SERVICE INSTRUCTION

RUNNING MODIFICATIONS ON

ROTAX® ENGINE TYPE 912/914 (SERIES)

SI-912-020R10

fig. 2

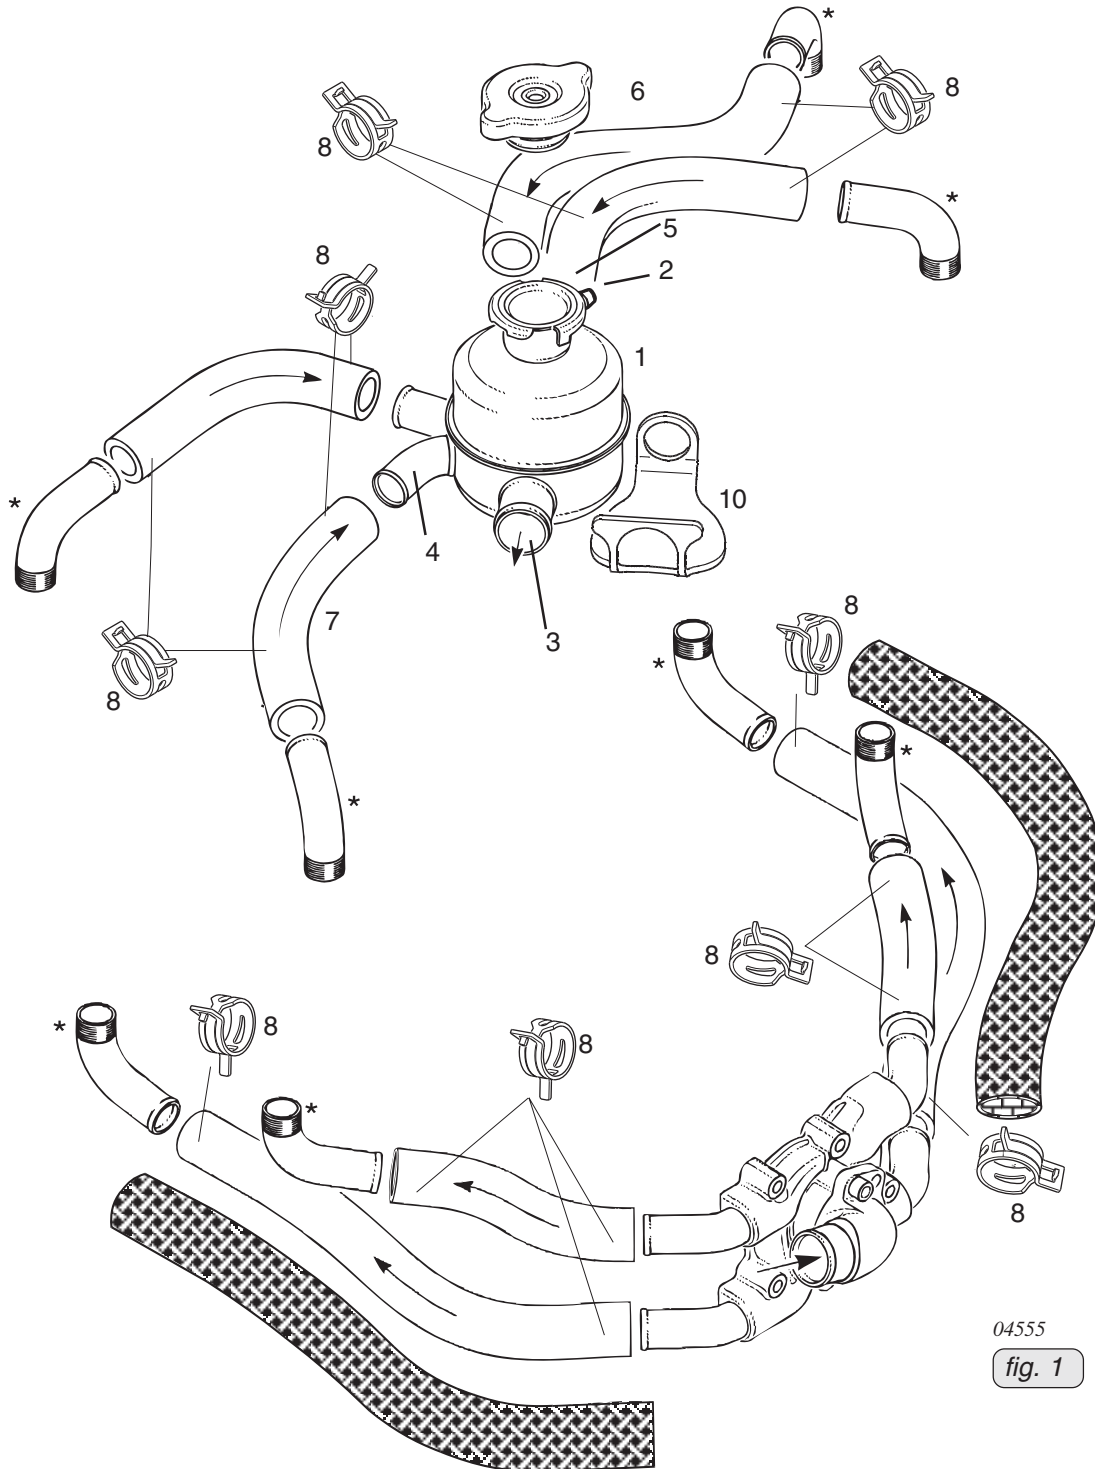
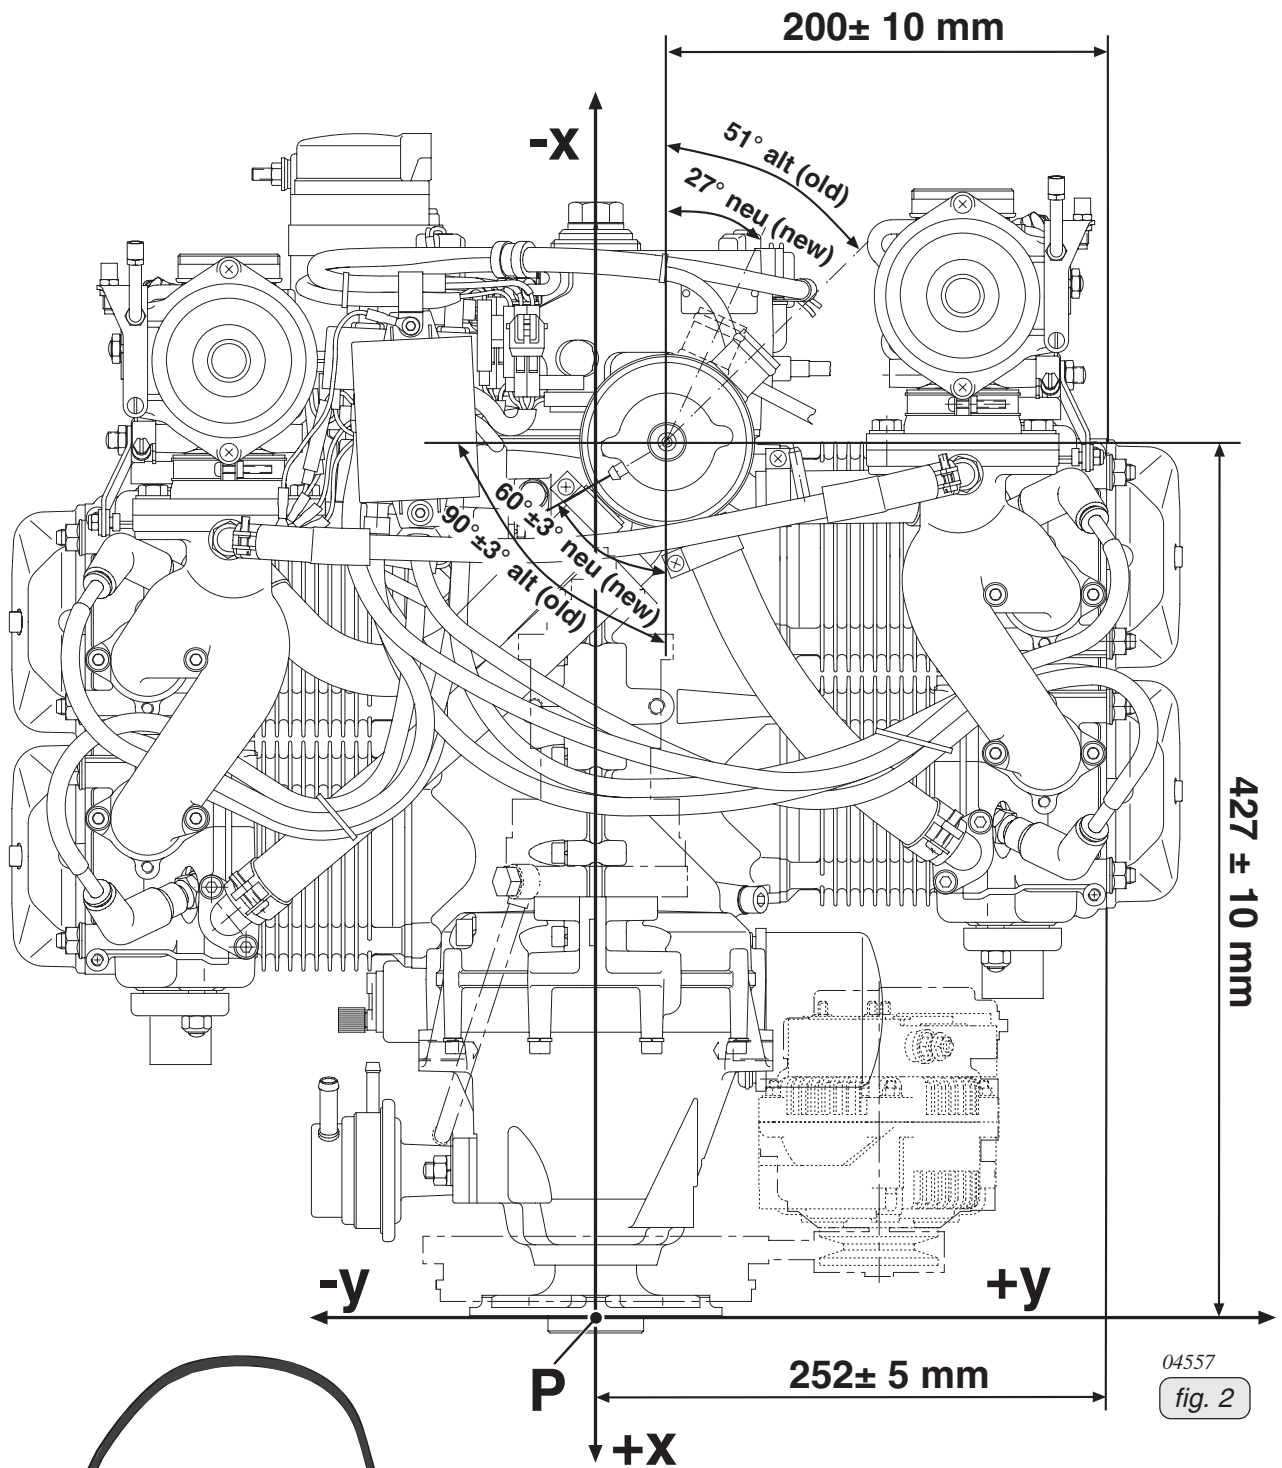
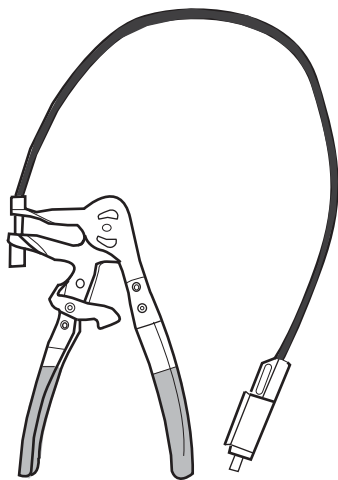
In the course of further development and standardization the position of the expansion tank (1) has been optimized!

- position of connection (2) to overflow bottle (from 0° to 30±3°)
- position of connection (3) to radiator (from 51° to 27±3°)
- angle of inlet socket (4) from cylinder 4 (34° inclined)
- length of inlet socket (5) from cylinder 3 (length increased by 13,4±3 mm)
- length of coolant hose (6) from cylinder 1 (length increased from 270 mm to 285 mm)
- length of coolant hose (7) from cylinder 4 (shortened from 100 mm to 85 mm)
- new spring type hose clamps (8) to attach the coolant hoses (expansion tank and water pump)

- Install the coolant hose (6) 285 mm to cylinder 1 and the new coolant hose (7) 85 mm to cylinder 4. For attaching all the coolant hoses from expansion tank, water pump, cylinders, use the new spring type clamps.

■ **CAUTION:** Take care of appropriate slip-on length of the coolant hoses on the corresponding connection socket. Verify tight fit of clamps and hoses and check for leakage. Always fit the clamps such that they can not wear on any component and use a suitable tool (see fig. 3) for fitting them.

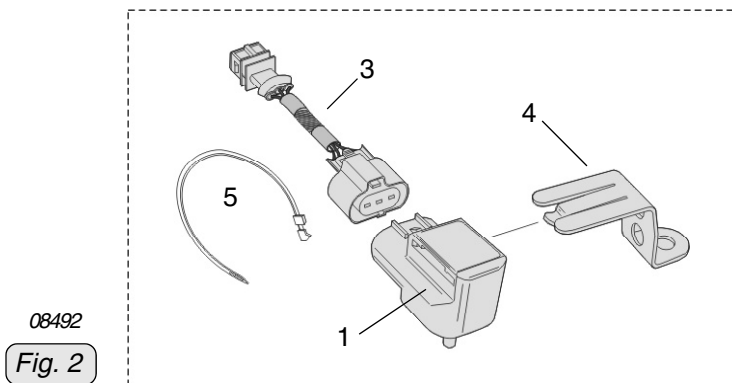
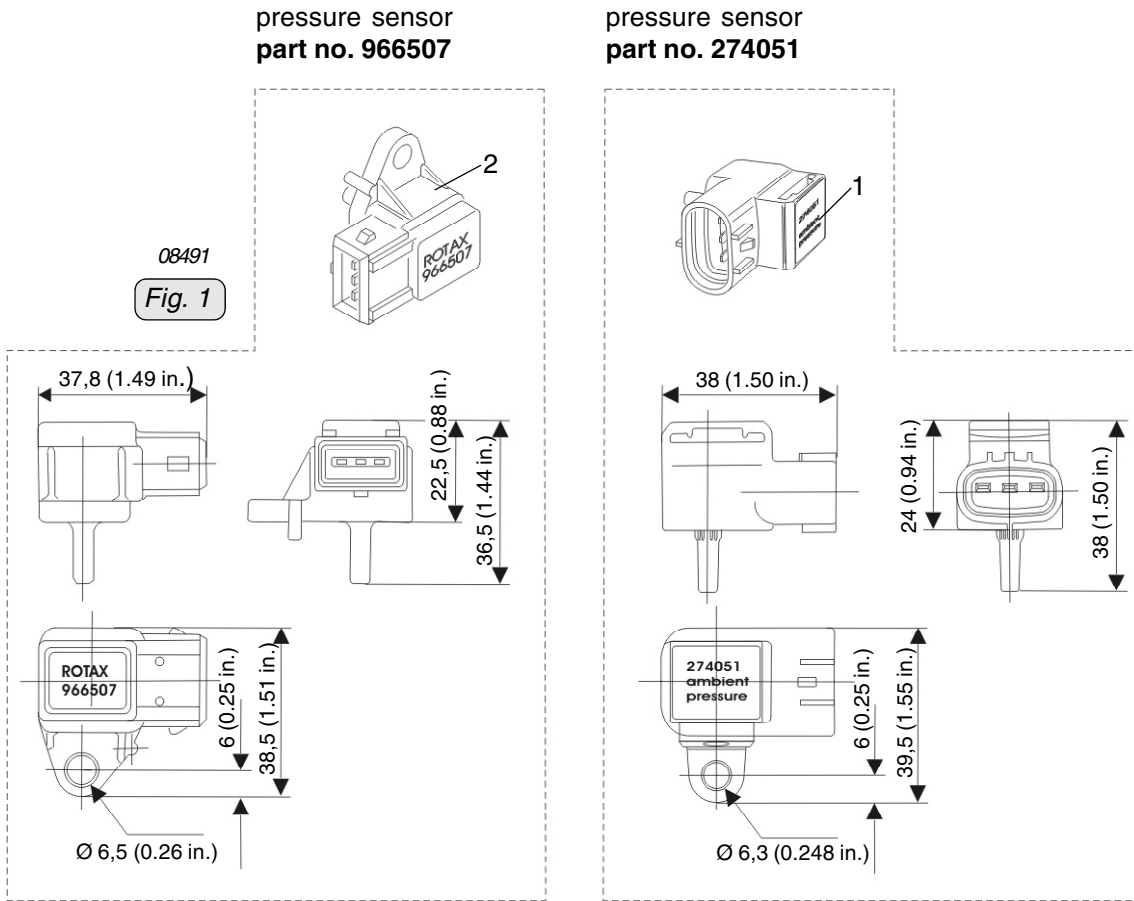
Due to the termination of production of the ambient pressure sensor (part no. 966507) a new ambient pressure sensor part no. 274051 has been introduced. The new ambient pressure sensor is of different size and also has a different connector. The connection for the wiring harness had to be changed.

1. Disconnect the pressure sensor (2) from the wiring harness.
2. Connect adapter cable (3) to wiring harness and to the new pressure sensor (1).
3. Install bracket (4) onto pressure sensor.

4. Position adapter cable and secure with cable binders (5).

new Version

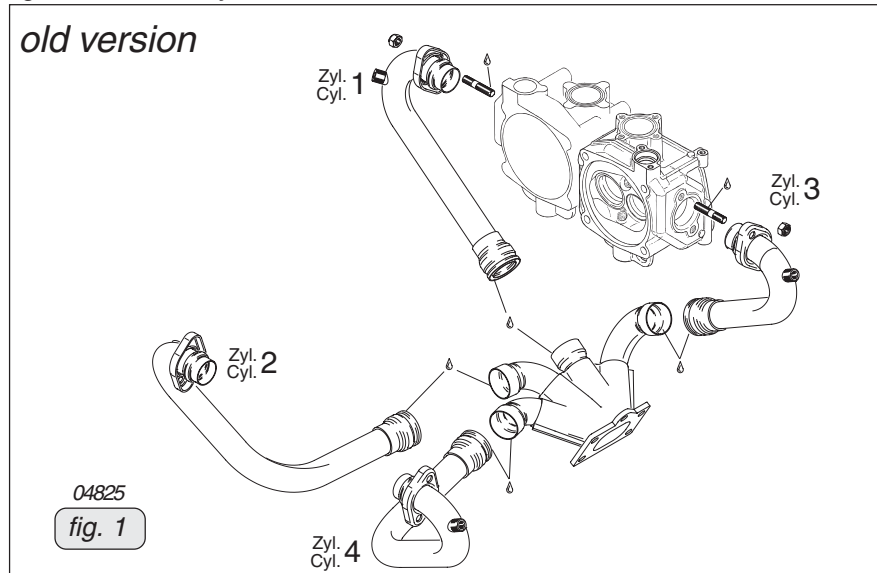
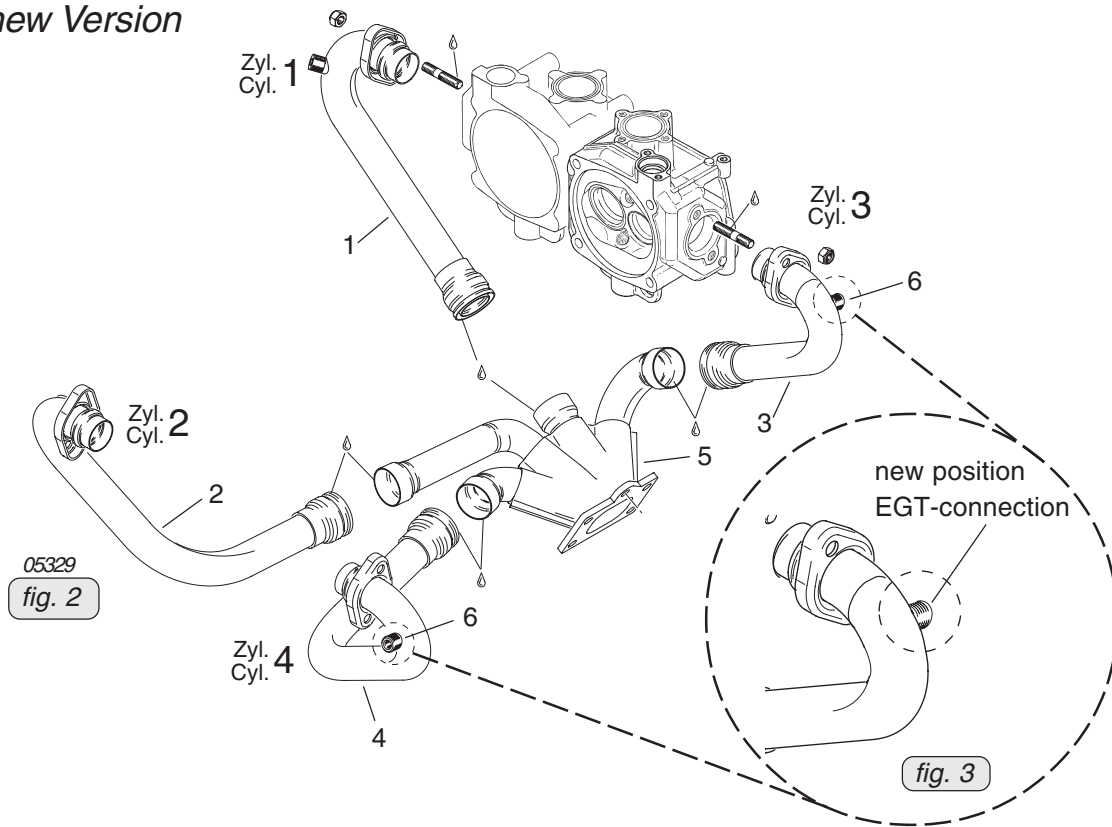
Owing to continuous further development, the exhaust bends were slightly re-worked. The couplings were optimized for their position.

- Position of the EGT connections (6) to the exhaust bends for cylinders 3 and 4 were routed such that installation of the new drip trays is possible.

fig. 1

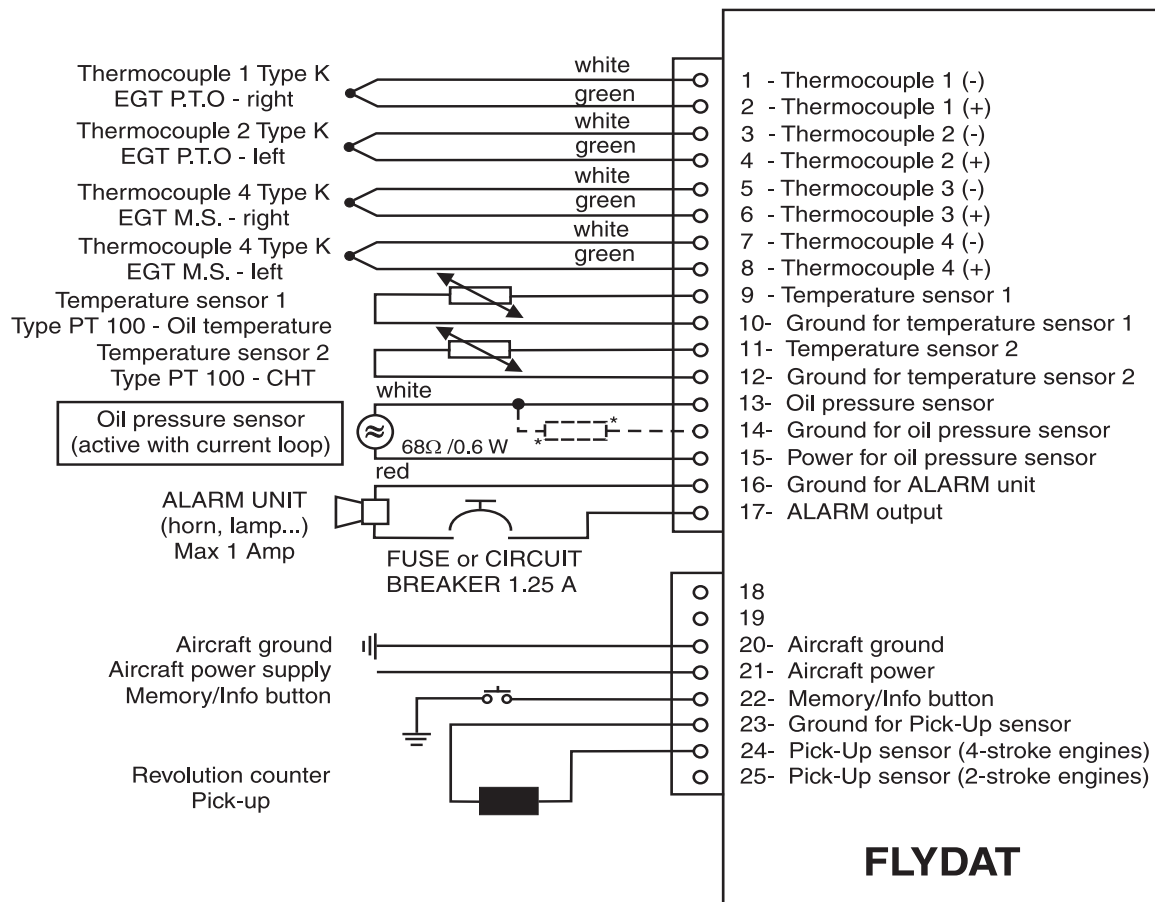
In the course of further development and standardization a new oil pressure sensor part no. 456180 has been introduced.

◆ NOTE: Due to a configuration of the electric oil pressure sensor on the ground are already about approx. 0.2 bar (3 psi) (depending on the sea level and ambient pressure) displayed.
